City of Carmel-by-the-Sea

Errata Memorandum

Planning Commission Meeting Date: May 14, 2025

Subject: DS 22-331 (Collins); San Carlos 3 southeast of 1st Avenue

Figure 3. Revised site plan with new tree planting locations. Green circle = tree to remain; Orange circle = Tree planned for removal (on city work order); Purple Circle = Proposed Upper Canopy Trees (Monterey pine)

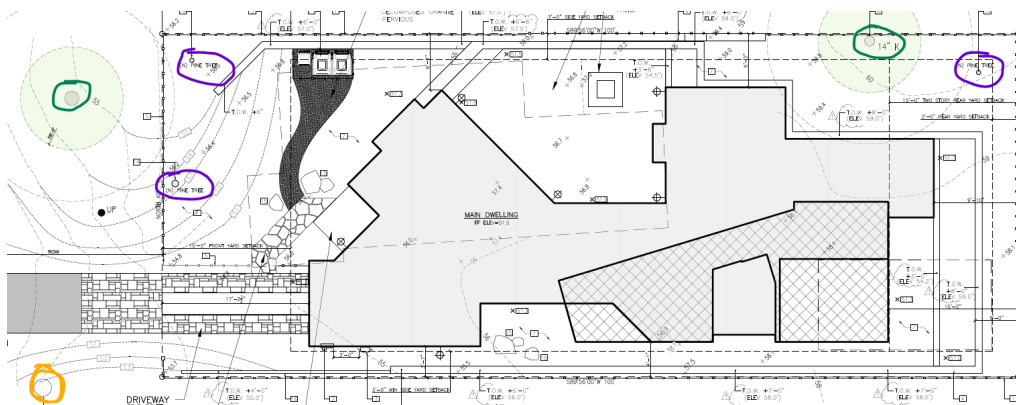
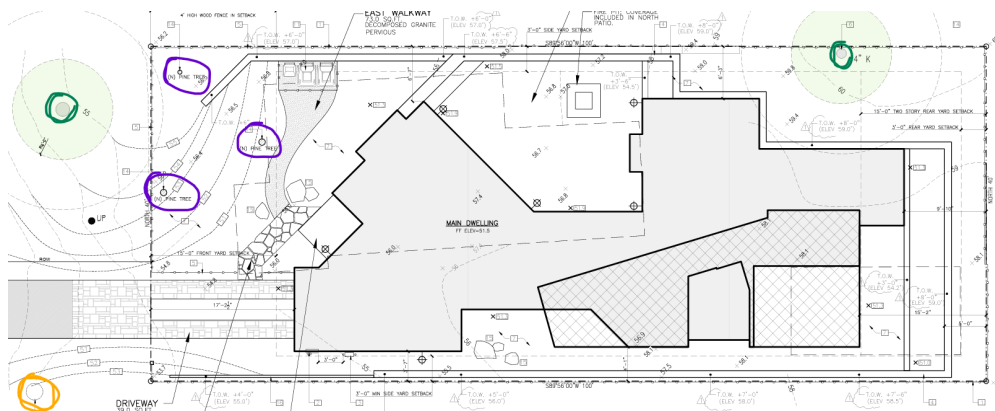
On May 12, 2025, staff and the project applicant received correspondence from an adjacent neighbor raising concerns regarding the proposed landscape plan, specifically the proposed locations of the upper canopy trees. The correspondence stated, in part: *"we object to the placement of the new monterey pine in the corner of the lot closest to our property at the SW corner of Mission & 1st."* In summary, their concern was primarily an issue regarding potential view impacts.

On May 13, 2025, staff received from the applicant a revised landscape plan and site plan that relocates one of the proposed upper canopy trees from the northeast corner of the site to the northwest portion of the site. With the proposed changes, all new upper canopy trees are proposed to be located at or near the northwest corner of the site (see enclosed and Figures 2 and 3, below).

Planning staff and the city forester has reviewed the proposed changes and finds the proposed alternative locations acceptable. The concerned neighbor is also agreeable to the proposed changes.

The enclosed site plan and landscape plan supercedes the proposed site plan and landscape plan included in the staff report as Attachment 3.
